ALERT SERVICE BULLETIN

204B-21-76

MODEL AFFECTED: 204B

SUBJECT: MAIN ROTOR SCISSORS & SLEEVE HUB
ASSEMBLY COLLECTIVE 204-011-405-013
IDENTIFICATION

Figure 1 – Hub Assembly Ink-Stamped Part Number and Serial Number

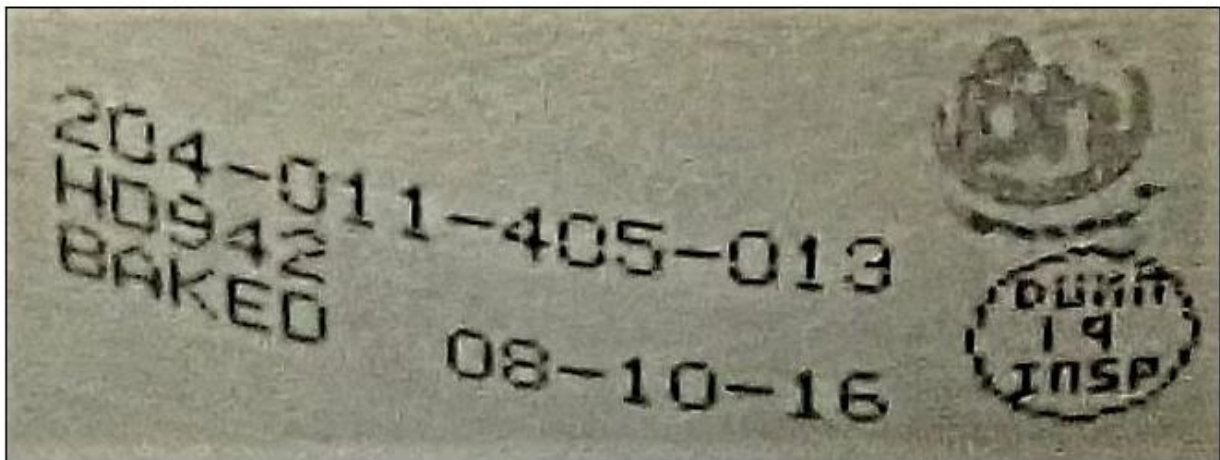
3. Gain access to the Hub Assembly 204-011-405-013 and inspect for the presence of part number and serial number matching the Historical Service Record (HSR) at the location shown on Figure 1.
4. If the Hub Assembly is not correctly marked, as shown in Figure 1, proceed with **PART II**.
5. If the Hub Assembly is correctly marked, as shown in Figure 2, make an entry in the helicopter logbook and historical service records indicating findings and compliance with **Part I** of this Alert Service Bulletin.
6. If **Part II** of this ASB is not going to be accomplished immediately, make an entry in the helicopter logbook and historical service records indicating compliance with **Part I** of this Alert Service Bulletin with an annotation to accomplish **Part II** within the required compliance time stated in this ASB.

2. If the Hub Assembly has an ink-stamped part and serial number matching the HSR (refer to example shown in Figure 1), permanently mark the part and serial number on the Hub Assembly by vibro-etching or dot-peening (Figure 2).
3. If the Hub Assembly does not have a part number and serial number, create a unique serial number for each Hub Assembly. Using one or two prefix letters consistent with the company name of the operator or repair facility accompanied by a dash and 4 or 5 digits is considered as an industry serial number marking standard. Vibro-etch or dot-peen the Hub Assy with the part number and the assigned serial number (Figure 2).
